### **SAN ONOFRE NUCLEAR GENERATING STATION**

#### **IMPROVED TECHNICAL SPECIFICATIONS CONVERSION**

##### **ITS SECTION 3.0 LCO AND SR APPLICABILITY**

**Current Technical Specification (CTS) Markup  
and Discussion of Changes (DOCs)**

EXAMPLE B 3.0.6-3 ← (Refer to Figure B 3.0-1)

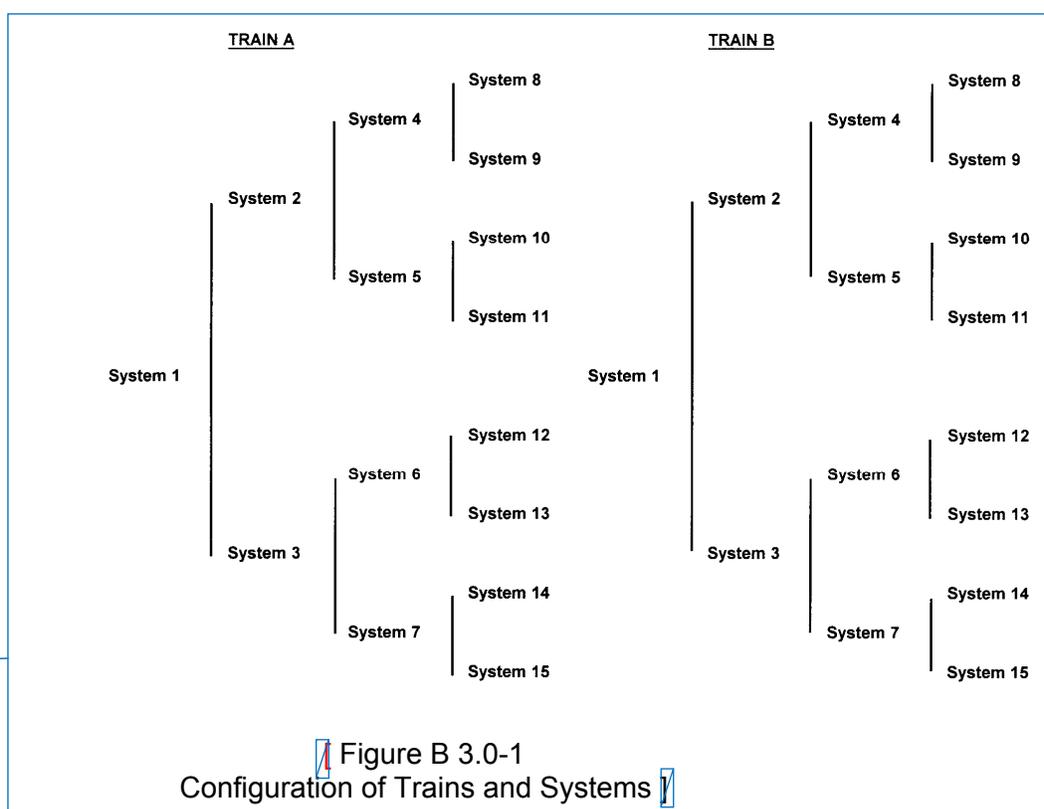
If System 2 of Train A is inoperable, and System 1 of Train B is inoperable, a loss of safety function exists in Systems 2, 4, 5, 8, 9, 10 and 11.

4. ISTS Figure 3.0-1 is being moved to the end of the Section, consistent with the format of the ISTS (Figures appear at the end of a Specification). Also, due to this movement, the Examples have been clarified to refer to the Figure.

- 1) Example B 3.0.6-1 is changed from "If System 2 of Train A is inoperable and System 5 of Train B is inoperable, a loss of safety function exists in supported System 5" to "If System 2 of Train A is inoperable and System 5 of Train B is inoperable, a loss of safety function exists in Systems 5, 10, and 11." Examining Figure B 3.0-1, it is clear that if there is a loss of safety function in System 5, there is also a loss of safety function in the systems supported by System 5, i.e., Systems 10 and 11. This relationship is explicitly listed in Example B 3.0.6-3 and to not do so here is inconsistent and confusing as it leads the reader to believe that Systems 10 and 11 do not have a loss of safety function. Furthermore, System 5 of Train B is not a supported System of System 2 of Train A, since they are in different trains. Thus, the word "supported" has been deleted.
